# UNITED STATES PATENT AND TRADEMARK OFFICE

APPLICATION NO.	FILING DATE	FIRST NAMED INVENTOR	ATTORNEY DOCKET NO.	CONFIRMATION NO.
10/538,553	06/13/2005	Juergen Buehler	D4700-00400	5069

<b>Office Action Summary</b>	<b>Application No.</b> 10/538,553	<b>Applicant(s)</b> BUEHLER, JUERGEN	
	<b>Examiner</b> Michael McDuffie	<b>Art Unit</b> 3632

The following correspondence is a non-final Office Action for application # 10/538,553, entitled: Swivel Arm Assembly for Plumbing Fixtures, filed on 06/13/2005. Claims 1-18 are pending.

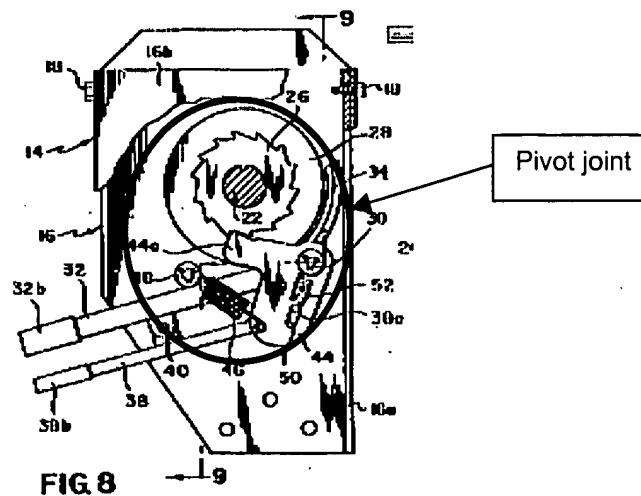
Regarding claim 1, Cohrs discloses an articulated-arm assembly, comprising: a mounting fixture **16** for fastening the assembly in place, an arm **24** jutting out of the mounting fixture **16**, a pivot joint (shown in Fig. 8 below) for joining the arm **24** to the mounting fixture **16**, a brake **28, 34** for locking the arm **24** in place, and a ratchet **26** that allows pivoting of the arm **24** in one direction.

Regarding claim 5, Cohrs further teaches the articulated-arm assembly, where the ratchet **26** has a pawl **44a** arranged on the mounting fixture **16** and where the pawl **44a** has a length equaling that of the sleeve or collar **24a**.

Regarding claim 16, Cohrs discloses the articulated-arm assembly, where a space accommodating at least one of the brake and the ratchet is sealed with respect to the ambient (as shown in Fig. 8).
